WSCC COUNTY ARBORICULTURAL OFFICER response to planning consultation

Application reference number: WSCC/052/20

Location: Land to the north of Eastergate and north-west of Barnham, PO22 0DF

Date: 9th December 2020

From dwg A29-WSP-LA-GA-002 rev G:

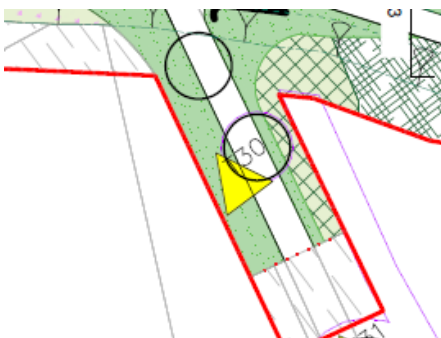
The drawing shows a hard surface path apparently through the middle of a TPO tree – is this correct? Will detailed bespoke method statements be forthcoming with regard to working and construction in close proximity to trees?
